## Driver Line Termination

This document includes.

1. A suggestion for a new section in PH2 on driver line termination.
  2. Notes on coupling capacitor
  4. Example of surface mount MLC series impedance vs freq.
  3. Example of a SSA40 line driver TDR .
- 
-

### 7.4 Line Driver termination

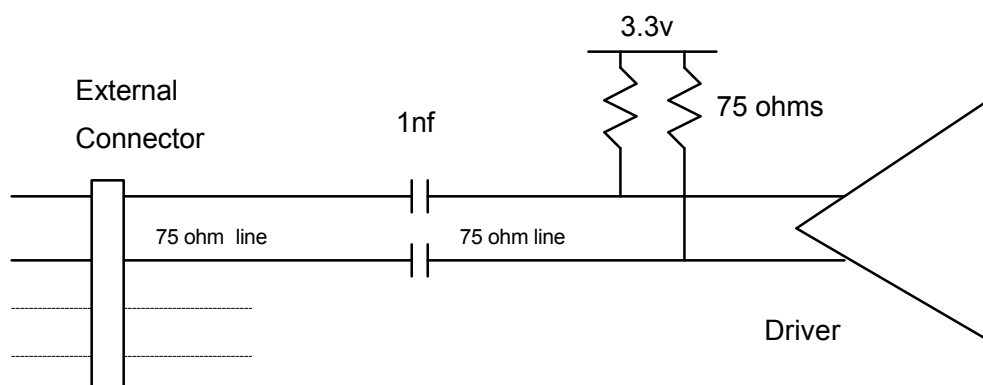
The diagram below illustrates the schematic of the driver termination.

The 75 ohm terminating resistor shall be +-1% and the 1nF capacitor shall be +-20%. The self resonant frequency of the capacitor shall be greater than 100Mhz and have a series impedance of less than 5 ohms at 400Mhz.
